Certificate of Appropriateness Case Report

Filing Date: March 25, 2014
Case No.: **2014.0425A**
Project Address: **981 Grove Street**
Landmark District: Alamo Square
Zoning: RH-2 (Residential, House, Two-Family)
40-X Height and Bulk District
Block/Lot: 0803 / 024
Applicant: William Duff Architects
26 O'Farrell Street, 2nd Floor
San Francisco, CA 94108
Staff Contact Alexandra Kirby - (415) 575-9133
alexandra.kirby@sfgov.org
Reviewed By Tim Frye - (415) 575-6822
tim.frye@sfgov.org

Certificate of Appropriateness Hearing
 Case Number 2014.0425A
 981 Grove Street
 Block 0803 Lot 024

Sheet Title
EAST ELEVATIONS

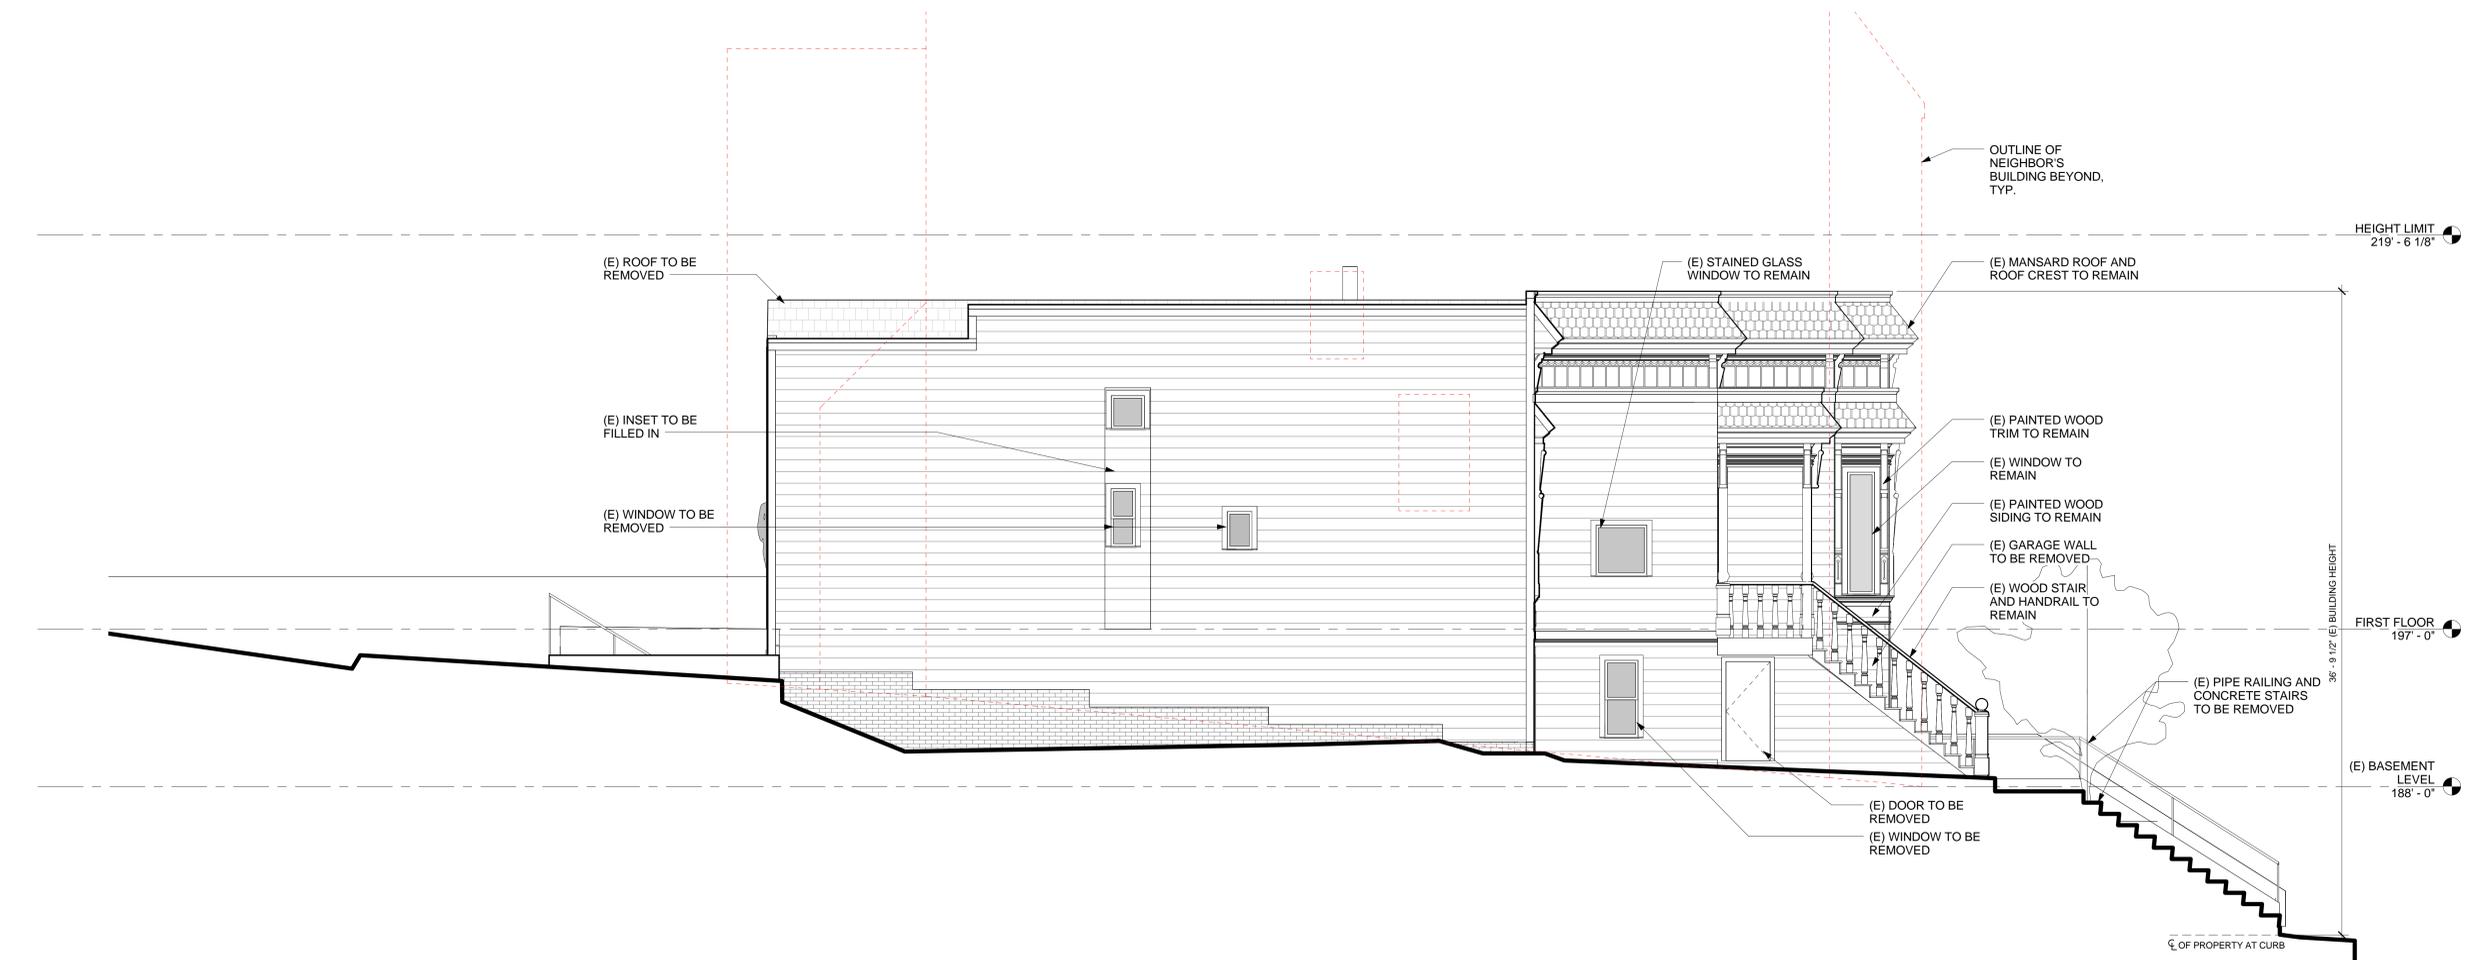
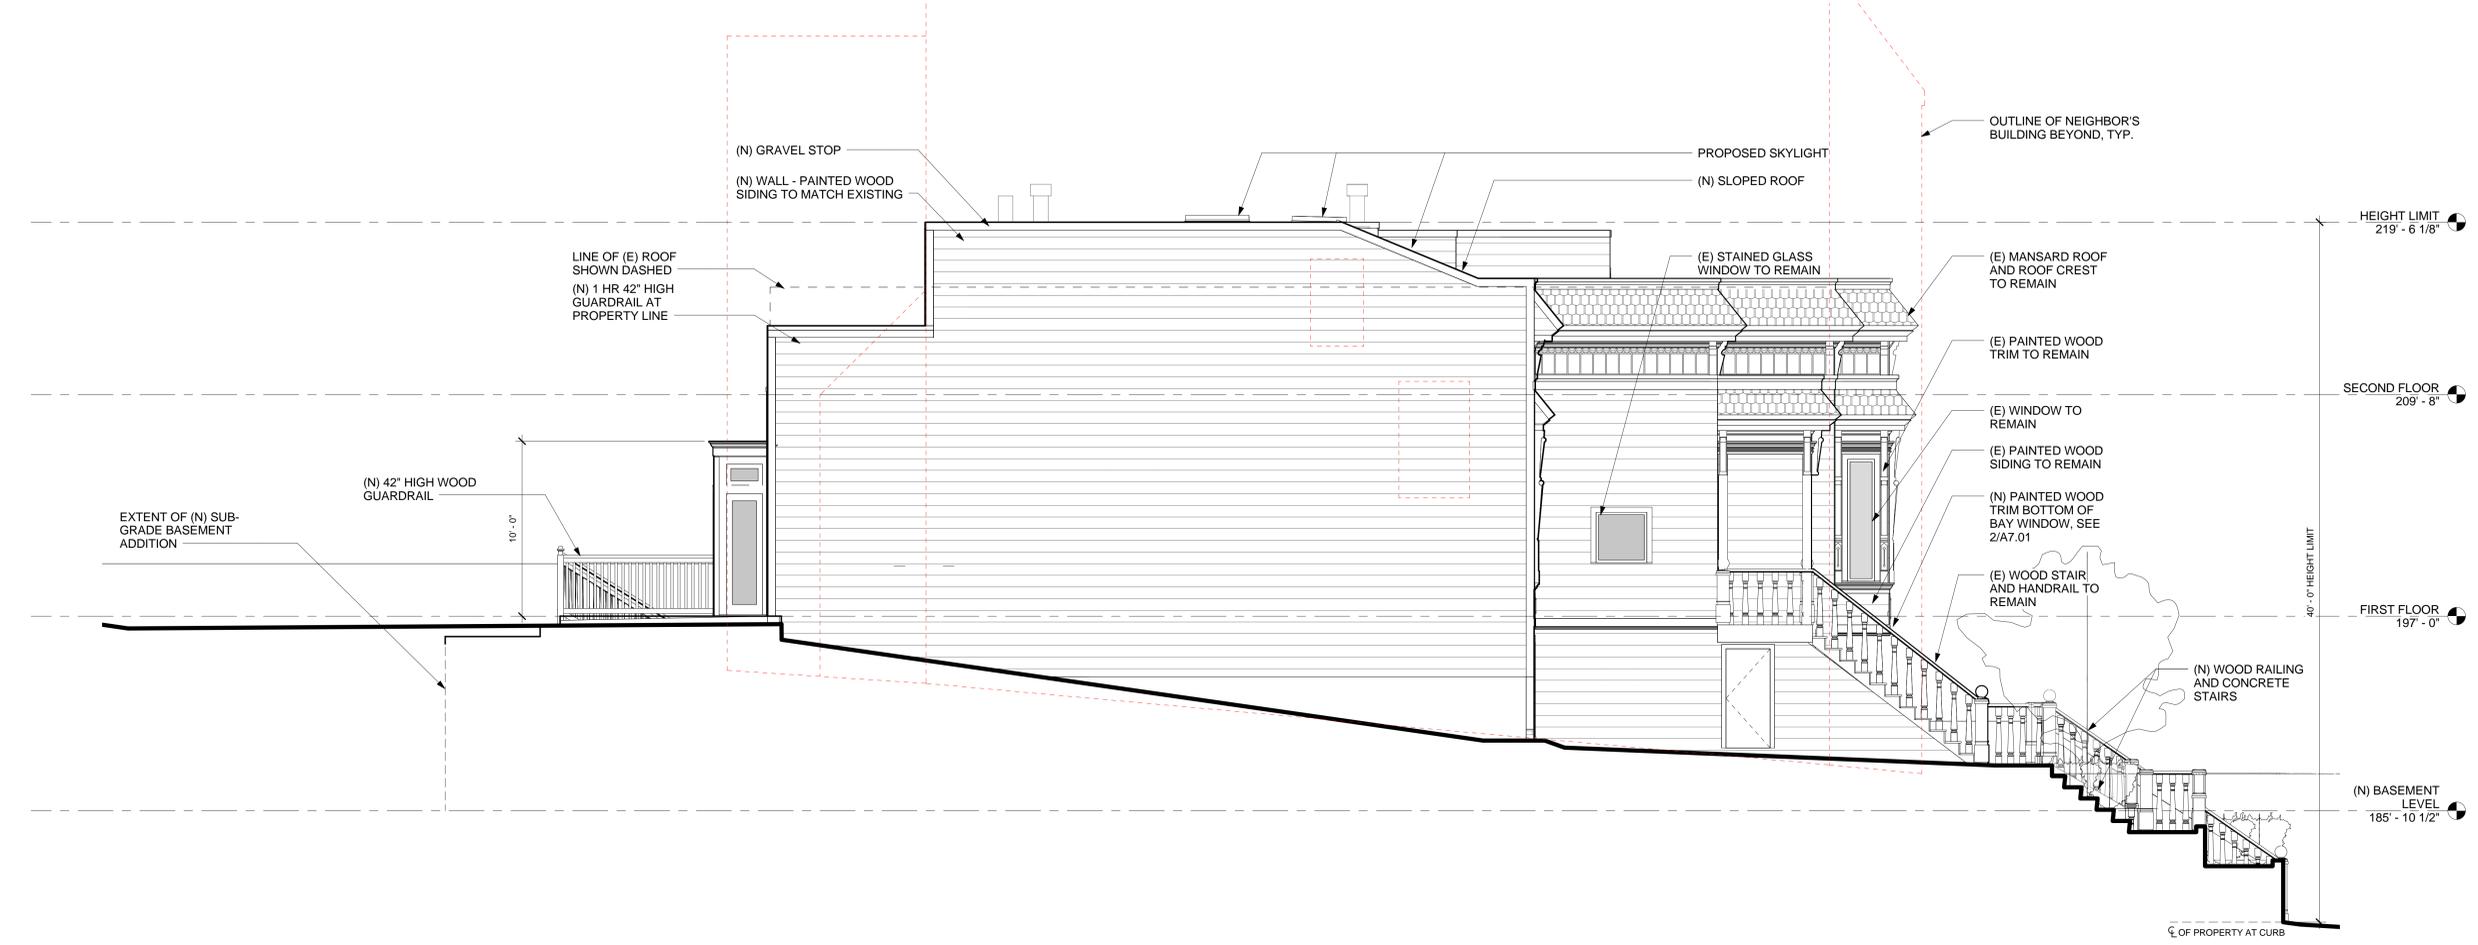
At the east elevation a small (1 foot by 2 feet) historic fixed pane window will be removed from the first floor as well as an historic niche featuring two windows. The proposed wall will be flush and entirely clad in horizontal wood siding. No new windows will be introduced at the new second floor.
